<b>Subject:</b> RATTLE NOISE FROM HEADER PANEL OF CONVERTIBLE TOP	<b>Bulletin No:</b> 09-045/15
	<b>Last Issued:</b> 12/23/2015

- This bulletin supersedes the previous bulletins 09-045/15 issued on 12/04/15. The WARRANTY INFORMATION has been revised.
- Changes are noted below in Red beside the change bar.

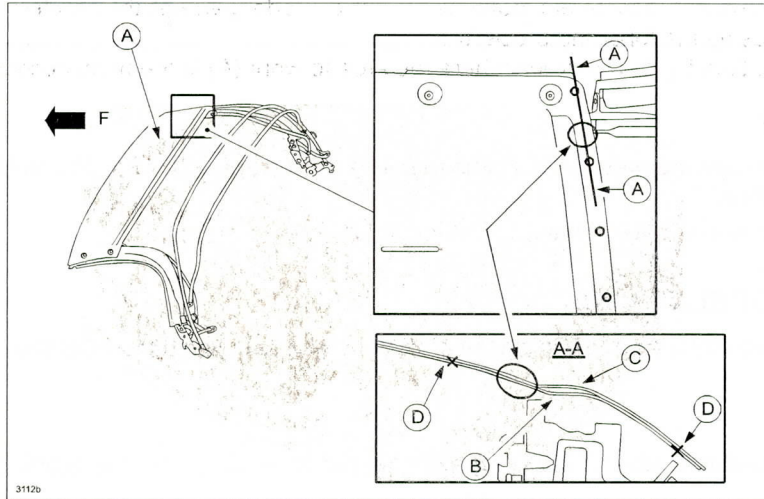
Some vehicles may exhibit a rattle noise (A) from the header panel (B) of the convertible top when driving on a rough road.

The header panel (A) is formed by two aluminum panels, inner (B) and outer (C). When receiving an input force by driving on a rough road, the two panels at the problem area, where spot welds are located (D), may warp and change relative position causing the rattling noise. (F=Front)
